DOCKET
07-AFC-4
DATE MAY 22 2008
RECD OCT 01 2008

Fact Sheet MMC Energy Peaker, 3497 Main St., Chula Vista

SOUTHWEST CHULA VISTA
CIVIC ASSOCIATION

Raoul Renauld, Hearing Officer
Christopher Myer, Project Manager
Members of the California Energy Commission

Maximum 24-hour PM2.5 in MMC Downwash Zone

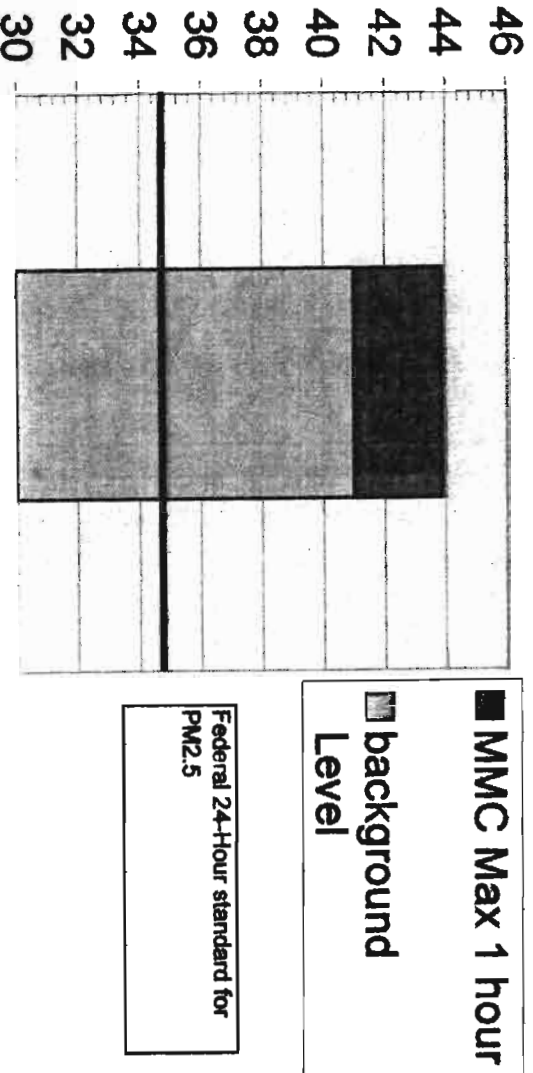
- In a comparison of emissions between 200 hours from the old power plant and more accurate hours of operation for the proposed plant- 500 and 4500, the proposed plant releases more emissions for each contaminant listed except for CO under the 500 hour analysis and for all contaminants under the 4500 hour analysis. (See related chart)
